TENDER BRIEFING MEETING MINUTES

MEETING DETAILS		
Description	Banana Shire Council – Don River Kellys Road Tender Briefing Meeting	
Venue	Physical: Banana Shire Council - 62 Valentine Plains Road Biloela Online: Microsoft Teams	
Date	Thursday, 20 th March 2025	
Time	08:00am – 09:00am	
Attendees		
Banana Shire Council (MRC) Representative		
Principal Project Engineer	Leesa Millar (LM)	
Lonergan Project Services (LPS) Representatives		
Project Manager	Antoine Aubin (AA)	
Project Director	Chris Amos (CA)	
Tenderer Representatives		
Business Name		Representative Name
1		Scott Northam
2		Wayne Gesch
3	Kingsline	Thusyanthan Arumainayagam
4	RH Contracting	Roger Hovermann
5	White House Group	Michael Sang
6		Marcelo Mariante
7		Jacob Ezzi
8		Courtney Hart
9	Civil RG	Cam

Banana Shire Council invites tenders from suitably qualified contractors to tender on the reconstruction works tranche 1 required due to the impacts from Central, Southern and Western Queensland Rainfall and Flooding, between 24 December - 3 January 2024 in more detail in "Part 5 - Banana T2425.30 Don River Kellys Road - Scope of Works". Works are expected to be completed before 30 June 2026.

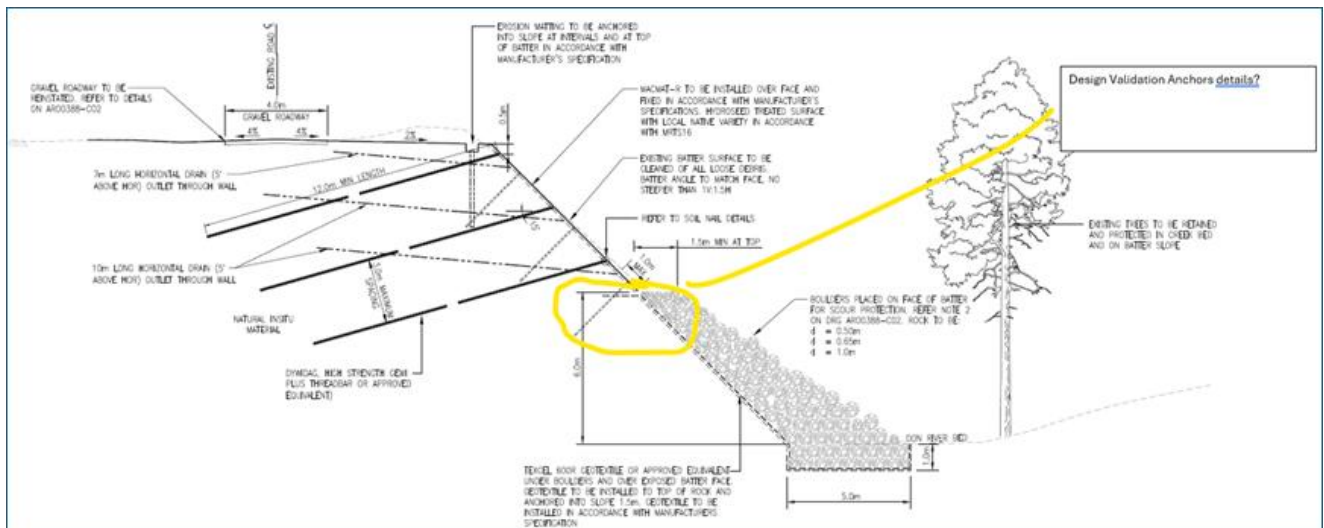
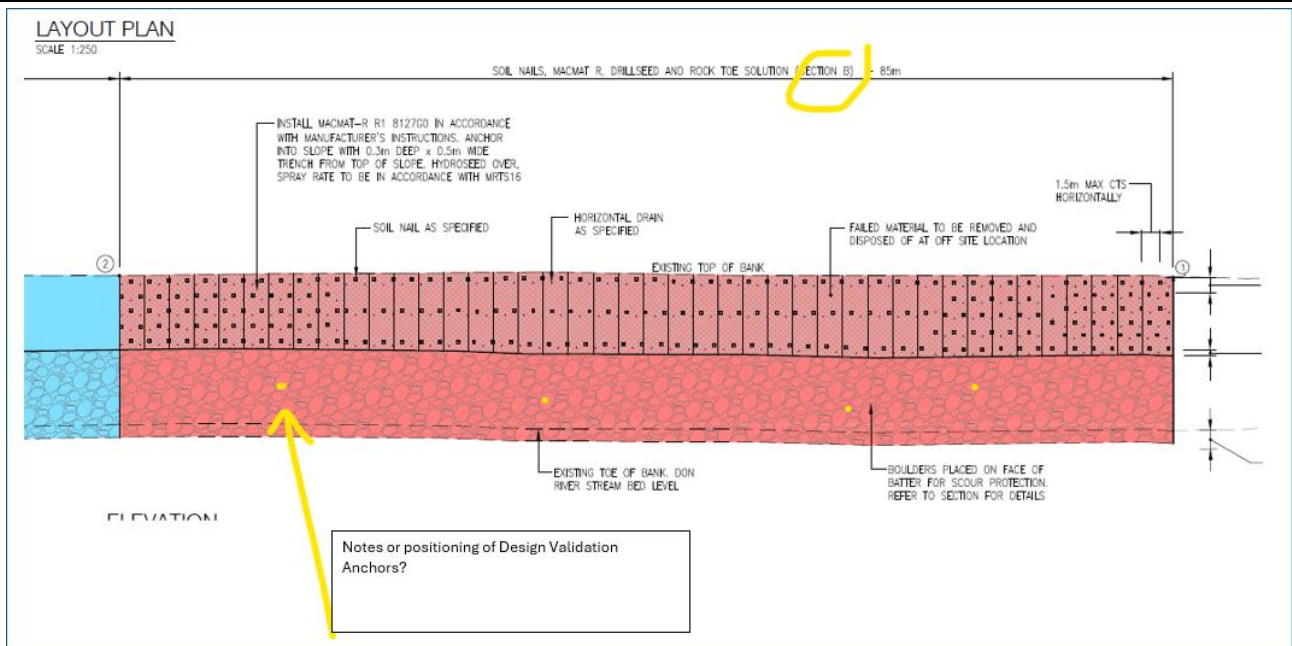
- The scope of works will be primarily rock armouring and soil nails.

- The design proposed includes rock armouring/protection placed at the base of the batter to a height of approximately 6m. There will be geofabric (TEXC EL 600R) placed behind the rock armouring along the full length.
- The Soil nails will be applied to Section B (corner) as per design. This treatment will include 12m soil nails, installed along the batter face. The surface treatment will be MacMat-R, which will be hydromulched with a native species blend once the matting has been applied.
- Section A- will largely be treated by the Rock protection only. (As per Section A)
- The Design has been reissued, and BoQ has been updated to reflect which will also be reissued via VendorPanel.
